**CITY OF PORT LAVACA – CITY HALL MASTER PLAN
PHASE 3 – INTERIOR RENOVATIONS AND SITE WORK**
202 N. VIRGINIA ST.
PORT LAVACA, TEXAS 77979
PROJECT #1043-1123

ADDENDUM NUMBER ONE

NOVEMBER 1, 2024

H4 INTERIOR ELEVATION - UTILITY SERVICE WINDOW
1/2" = 1'-0"

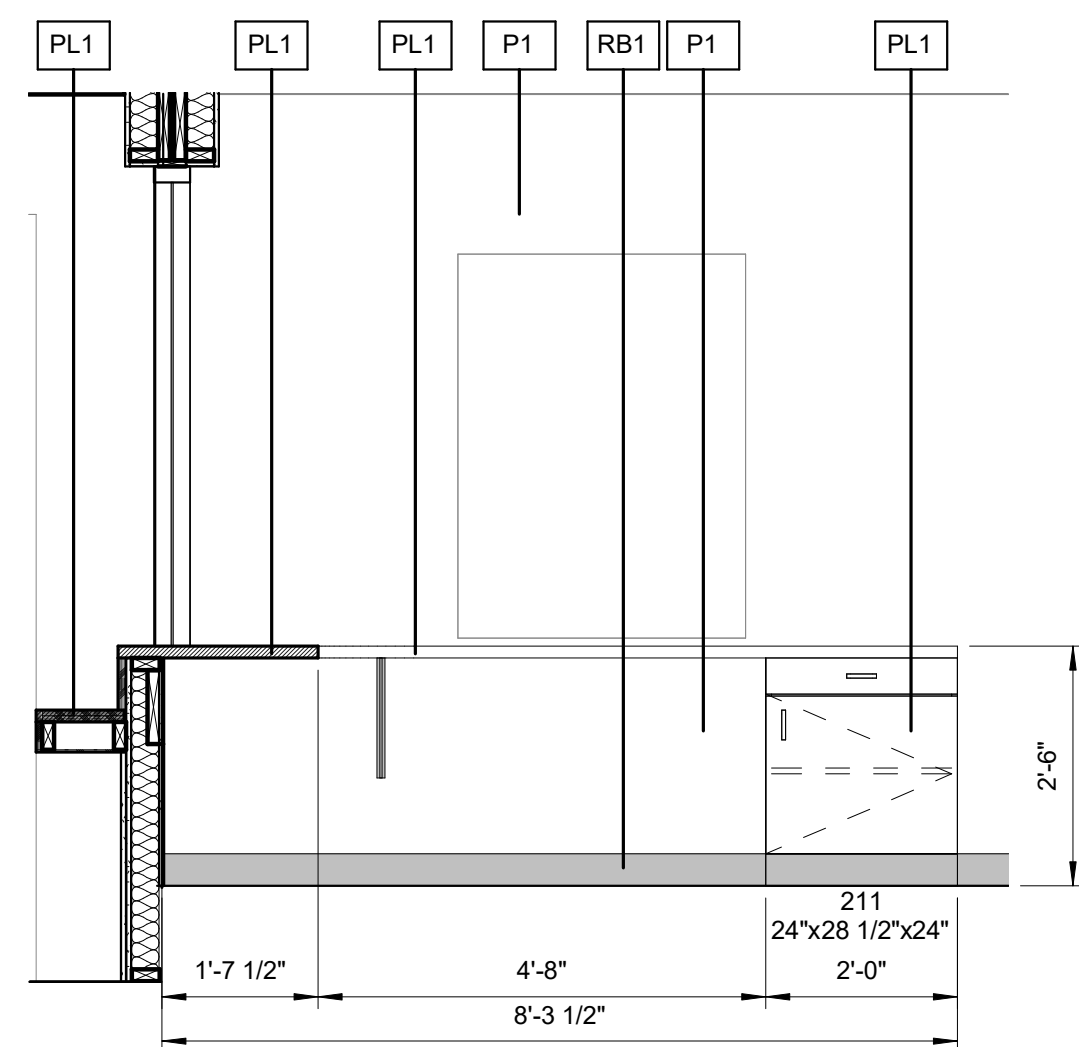
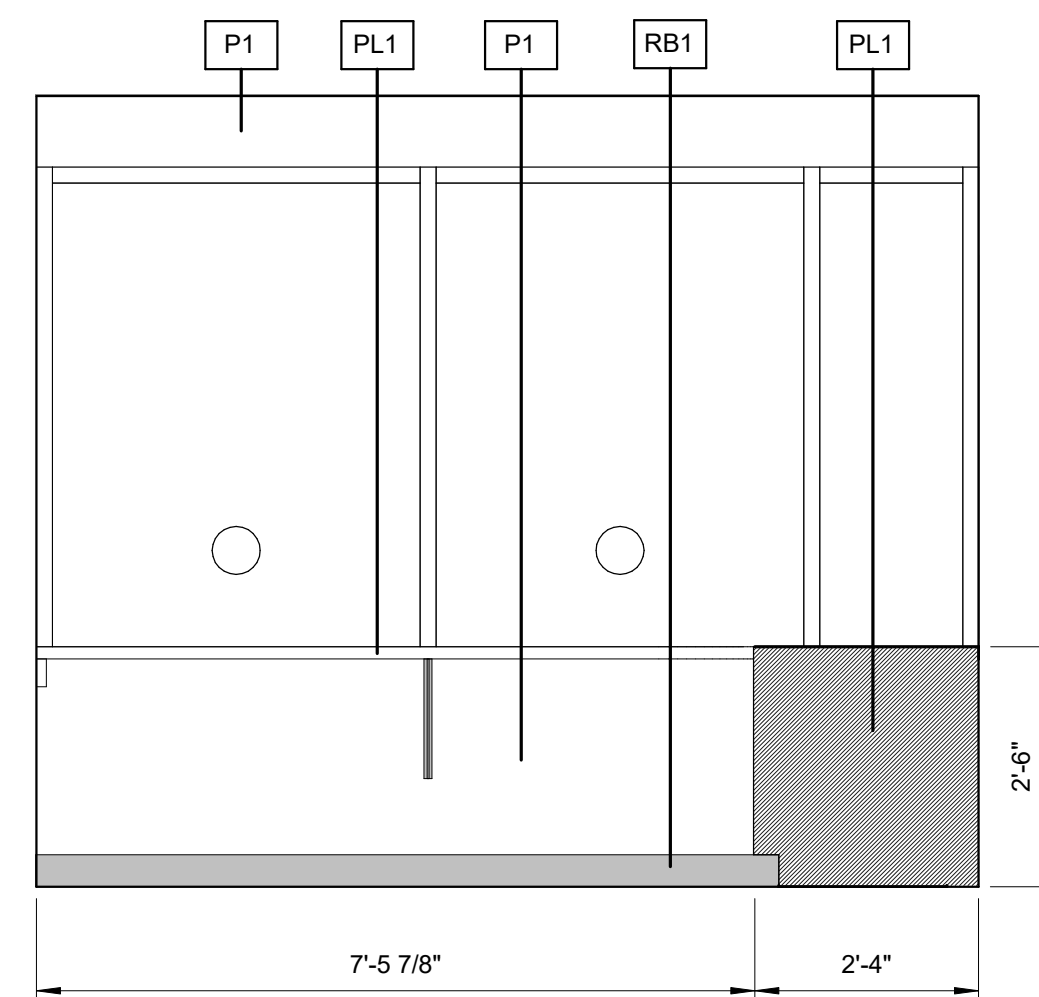
1. A1.1 DEMO PLAN, FLOOR PLAN, AND WINDOW ELEVATIONS
2. A1.2 RCP, WALL SECTIONS & DETAILS
